PLAN
AND SPECIFICATIONS
APPROVED
SUBJECT TO SUCH
CONDITIONS AS ARE
ENDORSED HEREON,
APPENDED TO THE
BUILDING PERMIT OR
ENDORSED THEREON.
Signed *[Signature]*
Building Inspector
Date 15-3-52

DETAIL 21

finger footing

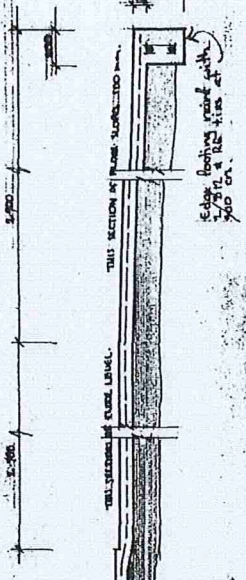
Extend 400-900 footing to 900-1200 under period columns. Add two extra 8/020 bars. Stirraps at 900 c/s to extend this floor slab to top 900 with mesh.

111. 111. TILI SLAB TYPE 3 (2 OFF)

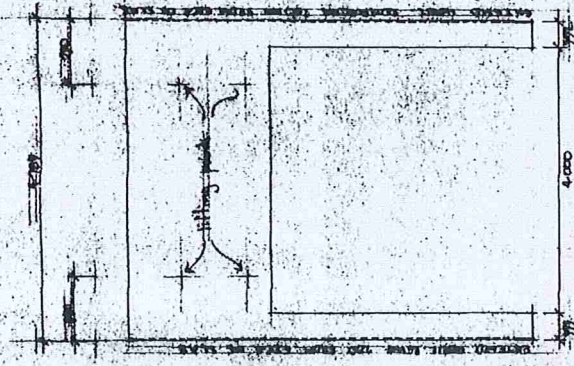
A 020 extra
400 x 300 ftg for 2m
